CITY OF COCONUT CREEK

DEVELOPMENT REVIEW COMMITTEE (DRC) REVIEW #1 – NOV. 06, 2025

PROJECT NAME:	Walmart Expansion		
PROJECT NUMBER:	PZ-25090001		
LOCATION:	5571 W Hillsboro Blvd		
APPLICANT/AGENT:	Bowman Consulting		
REVIEW/APPLICATION:	Site Plan		
DISCIPLINE	REVIEWER	EMAIL	TELEPHONE
DRC Chair Urban Design & Development	Deandrea Moise - Planning Manager	dmoise@coconutcreek.net	(954) 973-6677
Sustainability, Urban Design & Photometrics	Linda Whitman – Sustainability Manager	lwhitman@coconutcreek.net	(954) 973-6756
Urban Design & Signage	Natacha Josiah - Planner	njoshia@coconutcreek.net	(954) 973-6756
Transportation	Michael Righetti - Senior Project Manager	mrighetti@coconutcreek.net	(954) 973-6756
Building	Sean Flanagan – Chief Building Official	sflanagan@coconutcreek.net	(954) 973-6750
Engineering	Eileen Cabrera - Senior Engineer	ecabrera@coconutcreek.net	(954) 973-6786
Fire	Ryan Banyas – Fire Marshal	rbanyas@coconutcreek.net	(954) 956-1563
Landscape	Scott Peavler - Landscape (consultant)	speavler@craventhompson.com	(954) 739-6400

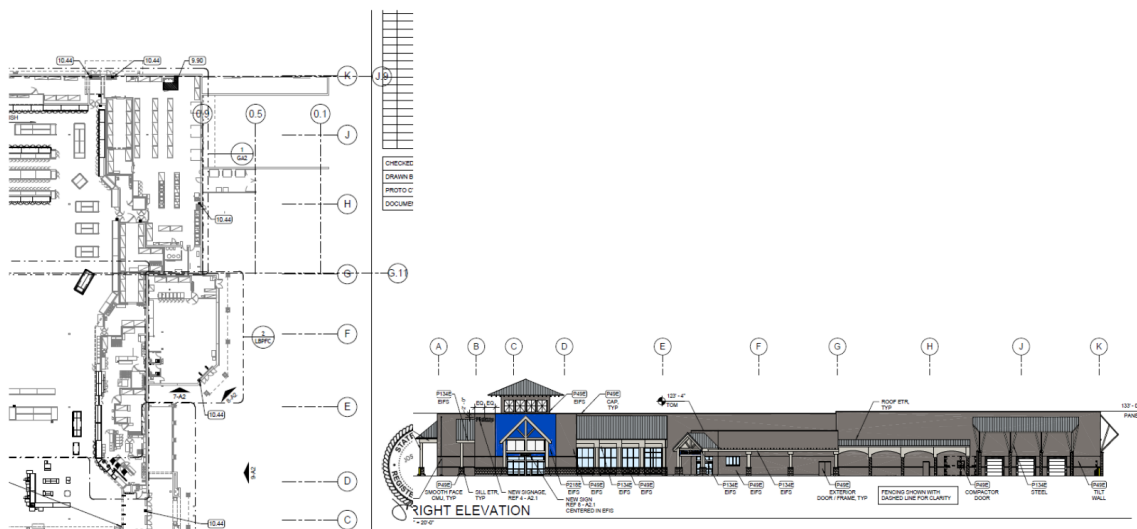
8. The first two pictures are from the 1916-251 you referenced; however. On the C1.1 Site Plan, you can see the addition jets out much further than the liquor store. The renderings on the 1916-251 don't reflect that. You can change the comment to say that the addition wasn't included in the color rendering on the 1916-251. We specifically are interested in seeing what the south wall of the addition will look like with the door that the employees will be using to enter and exit the addition.

C1.1 Site Plan

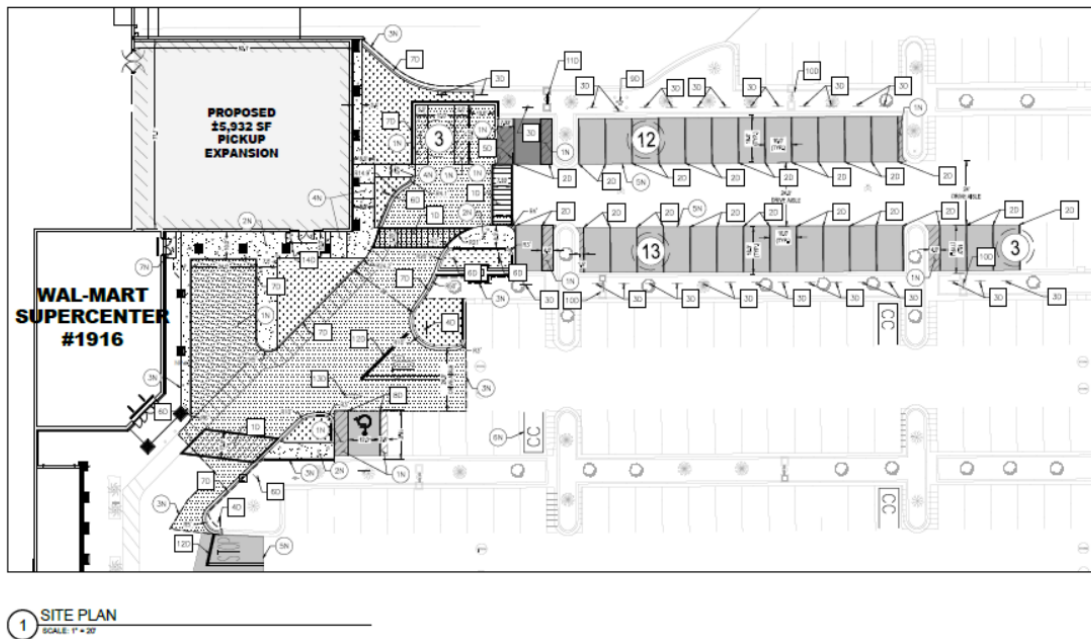
18. Sheet label C1.1, Site plan clearly identifies the proposed addition. However, the rendering provided doesn't reflect that. Revise accordingly.
19. Provide existing elevations in addition to proposed elevations.
